DART SERVICE INSTRUCTION

TO AMEND INSTALLATION INSTRUCTIONS IIN-D135-1027 REV. E AND
INSTRUCTIONS FOR CONTINUED AIRWORTHINESS ICA-D135-1027 REV. 2 OR LATER APPROVED REVISIONS
REF. TCCA STC: SH18-49
REF. FAA STC: SR04276NY
REF. EASA STC: 10068097
REF. DGAC MEXICO STC: IA-633/2019

DRAWING NO.
DSI 9853

TITLE
STEP COMPATIBILITY

FIGURE 1
EC 135 LANDING GEAR

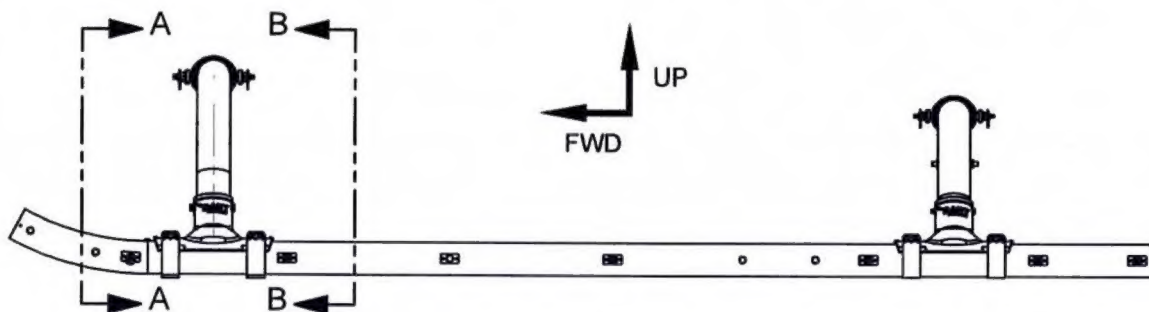
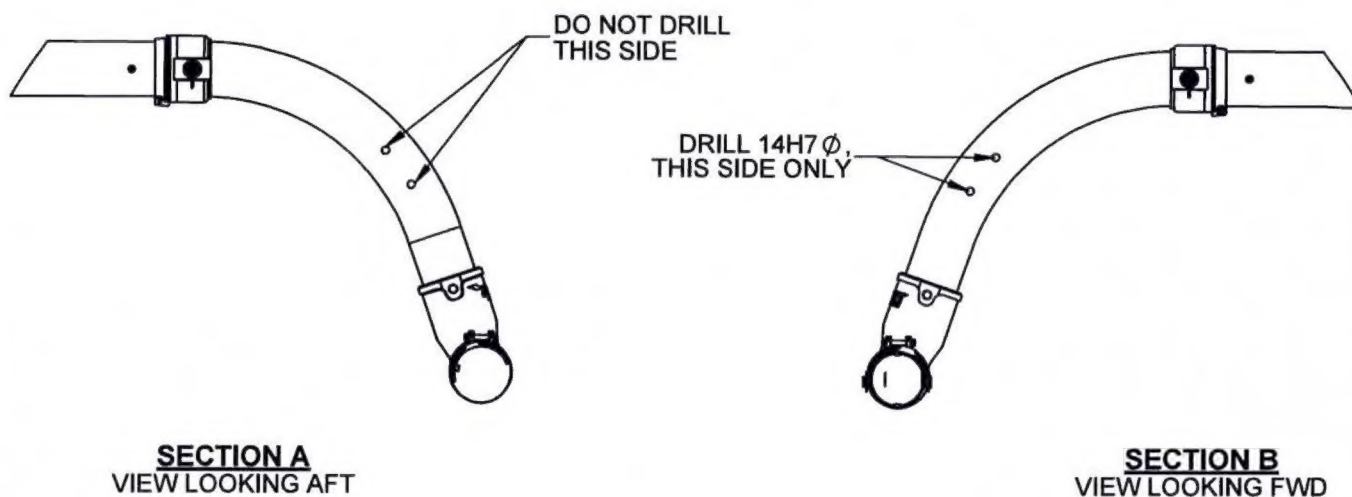
- 2.1 If present, remove standard entrance step and attachment hardware from landing gear in accordance with Airbus Helicopters SB EC135-32-013.
- 2.2 Drill 14H7 ϕ (range of tolerance 14.0 mm to 14.018 mm) on the aft side of forward crosstube only. Leave the holes in the forward side of the forward crosstube at ϕ 12mm. Refer to Figure 1 of this DSI.
